Technical Service Bulletin

Product: CP150 Electrocardiograph **Date:** 2015-12-27

Subject: CP150 2.00.06 Software Update – Save to Network Location & Rhythm Print Stutter Solutions

An example of the affected Rhythm printout is shown below:

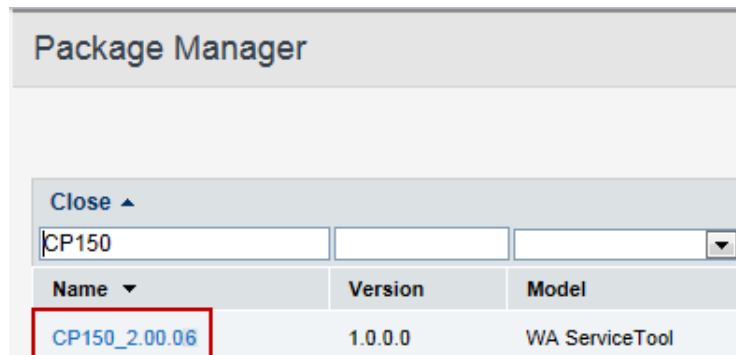
1. **Save to network location:**
In all past versions of the CP150 firmware, the ability of the CP150 to mount to a remote file location was not always successful. This update will allow the mounting to always be successful when the following conditions are met:
 - a. Shared File Computer and CP150 are both on the same subnet
 - b. ICMP (Internet Control Message Protocol) is enabled
 - c. Shared File Computer can be pinged using the Host Name
 - d. Shared File Computer is using NTLM v2
The update also adds the \$ character to the On-Screen Keyboard to support mapping to hidden folders.
2. **Rhythm Print Stuttering:**
When performing a Rhythm (continuous) ECG on a CP150 with firmware version 2.00.05 installed, the device may produce a rhythm print that continuously starts, stops and restarts, producing gaps in the data. This update will resolve this issue.

← = Calibration Pulse / Restart of Rhythm Print

↗ = Gap in data

NOTE: This issue does not occur on firmware versions prior to 2.00.05.

Provide the 2.00.06 update for devices exhibiting either, or both, of these issues. The update will be deployed to customers via PartnerConnect and the Welch Allyn Service Tool. Deploy Software Package **CP150_2.00.06**:
